SERVICE BULLETIN

NUMBER 517

DET-1620 for use with
CPU-95EVS

WIRING DIAGRAM
DET-1620 TO CPU-95EVS
ENHANCED VARISPARK IGNITION SYSTEM

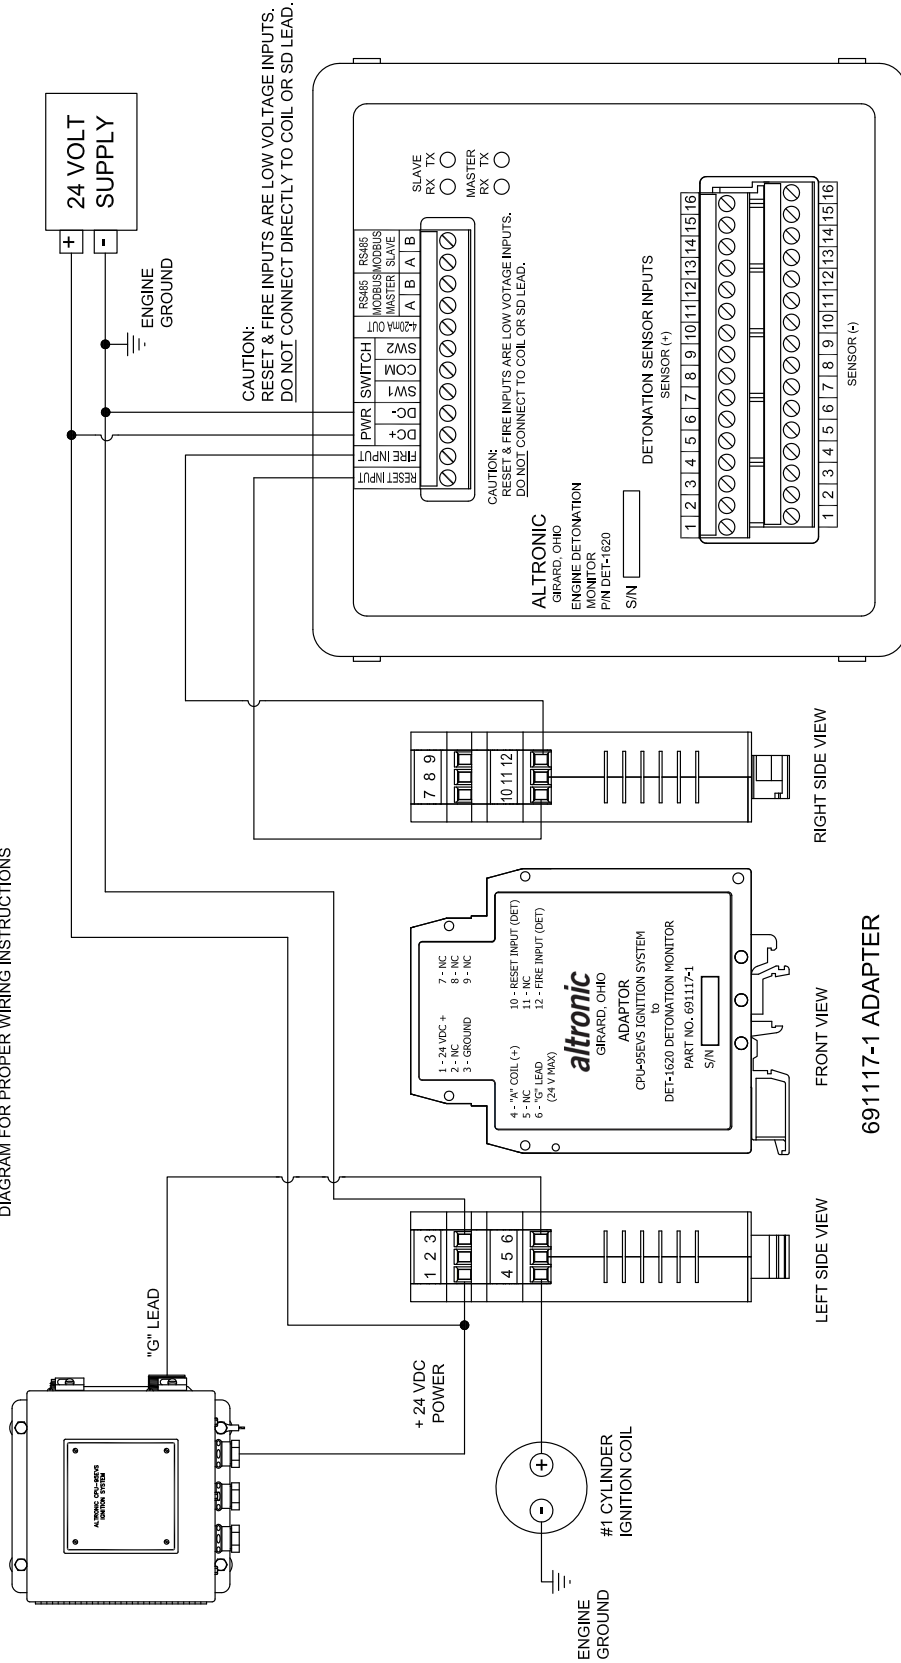
Detonation Sensing applications that employ the CPU-95EVS will require the specification of the DET-1620 along with an adapter (691117-1) to condition the “A” coil connection along with the “G” lead connection. This module has a current user price of \$152.00 and is available for order.

The DET-1600 cannot be used with the “EVS” version of the CPU-95.

NOTE: A 691117-1 ADAPTER IS NECESSARY FOR THE "A" COIL AND "G" LEAD CONNECTIONS FROM THE CPU-95EVS IGNITION SYSTEM TO THE DET-1620 ENGINE DETONATION MONITOR. REFER TO THE DET-1600 INSTALLATION/OPERATION MANUAL AND TERMINAL PROGRAM FOR ALL OTHER INSTALLATION, OPERATION, AND CONFIGURATION INFORMATION. WIRING DIAGRAM FOR PROPER WIRING INSTRUCTIONS
